MEMORANDUM

Date: May 1, 2020	
To: Gian Martire, Senior Planner	Organization: City of Cupertino
From: RRM Design Group	Title: Design Review Team
Project Name: Cupertino Consulting Arch. Review Services	Project Number: 1832-00-UR19 (20-01)
Topic: Westport Design Review – Tower Element

Location of Proposed Tower Elements.

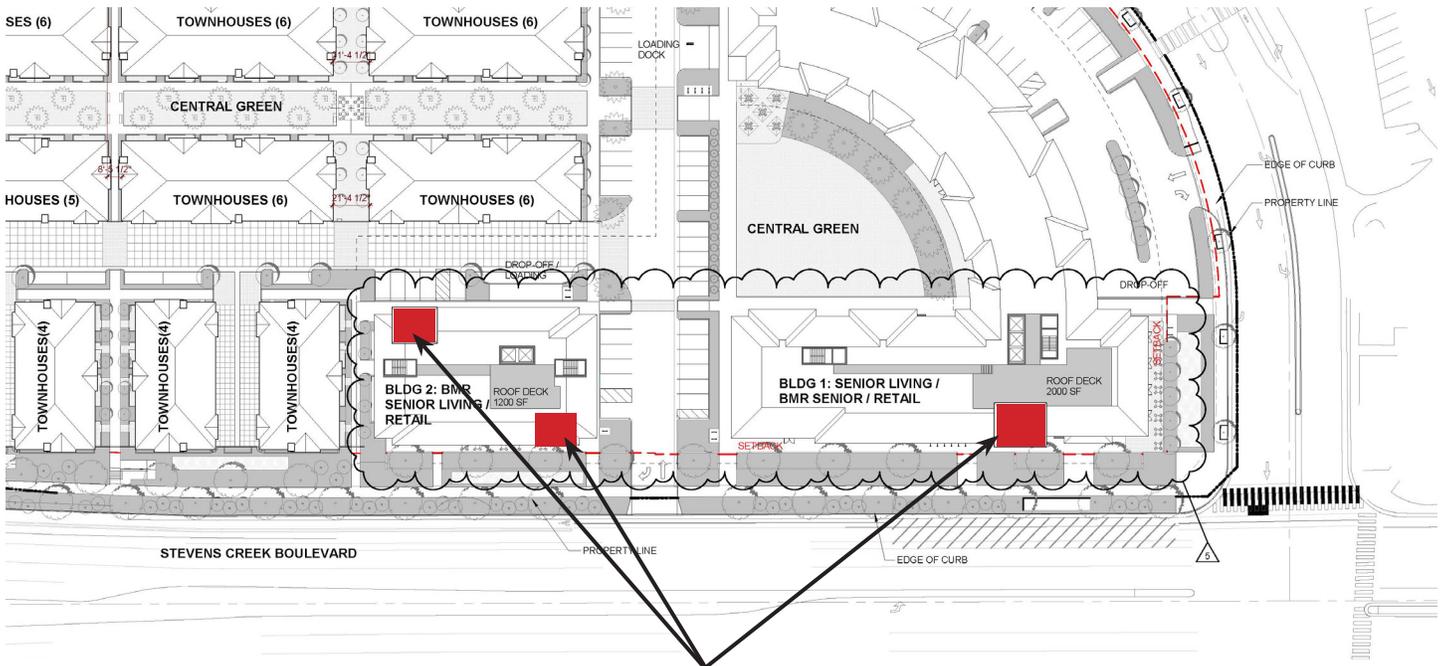
As seen on Site Plan Sheet A001, the applicant is proposing two separate mixed-use buildings along Stevens Creek Boulevard and a portion of Mary Avenue. Building 1 is proposed to have one tower element along Stevens Creek Boulevard and Building 2 is proposed to have two tower elements, one along Stevens Creek Boulevard and one facing the internal drive aisle of the project site. In general, while these individual building elements are consistent with the overall architectural style direction for the project and aide in breaking up the building expanse (HOCSP 2.01.010.A), the tower elements could be significantly improved as they appear overly monumental in scale, lacking in adequate pedestrian orientation, and are unrelated to primary building entrances.

Project Rendering

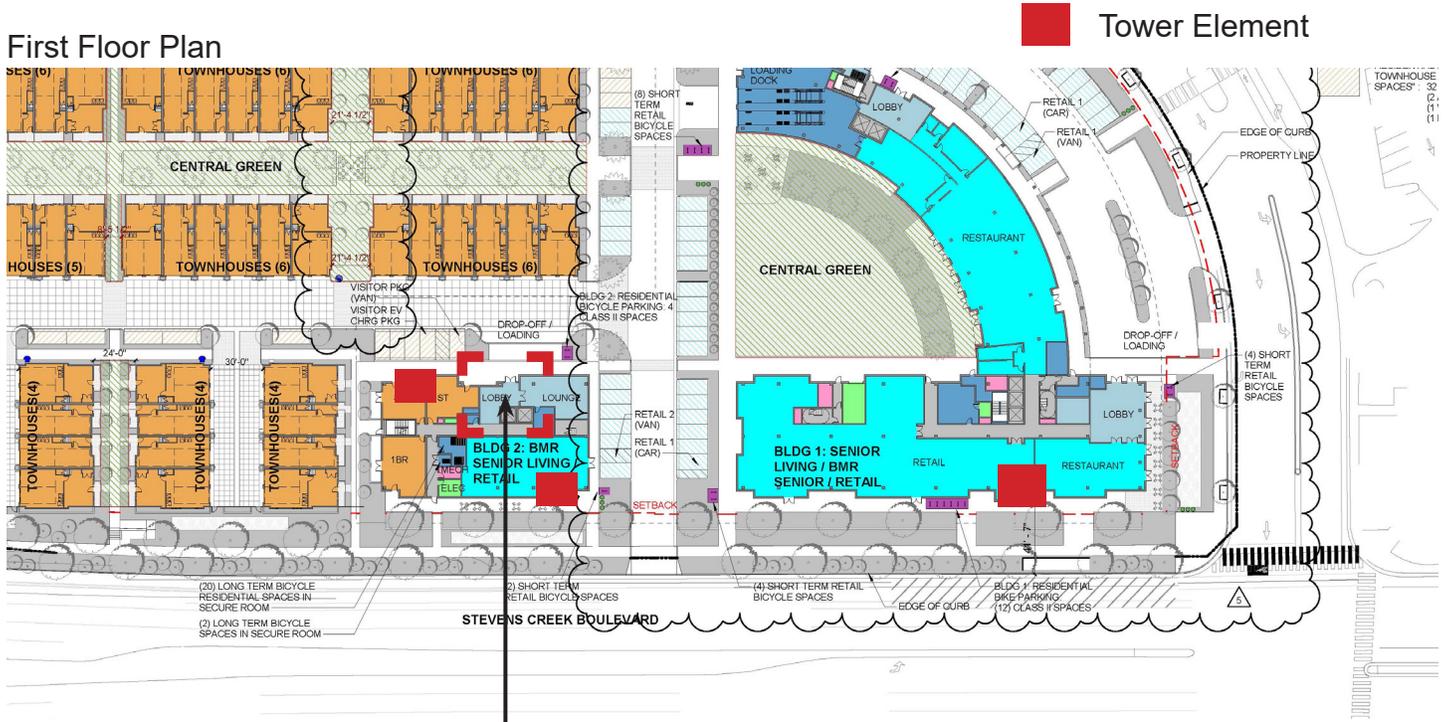
As noted in the HOCSP, primary building entrances and/or tenant spaces should be provided with a base, clear patterns of openings and surface features, prominent main entrance, and an attractive and visually interesting roofline (HOCSP 2.01.010.D). The design of the tower elements, while potentially visually interesting from a certain distance from the project site, are monumental in scale and lack the expected level of interest and orientation at the pedestrian-level on-site (HOCSP 2.01.010.D). For example, a projecting tower massing element at lower height, attached roof form at a lower height, awning/overhang at the first floor, and/or change in color/material application, among other possible design interventions, could aide in providing more visually interesting and easily identifiable primary building entrances to future residents and visitors on-site. Going forward, the applicant should revise the primary building entrances for both Building 1 and Building 2 to provide greater visual interest and orientation at the pedestrian level on-site.

Provide greater visual interest and orientation at the pedestrian level.

Opportunity for awning/overhang or change in color/material.

1. Revise the primary building entrances for both Building 1 and Building 2 to provide greater visual interest and orientation at the pedestrian level on-site (HOCSP 2.01.010.D). Possible design solutions could include a projecting tower massing element at a lower height, attached roof form at a lower height, awning/overhang at the first floor, and/or change in color/material application, among other possible design interventions.
2. Pursue revisions to tower location to better highlight the primary entrance for the residential portion of Building 1 and/or highlight building corners (HOCSP 2.01.010.B).
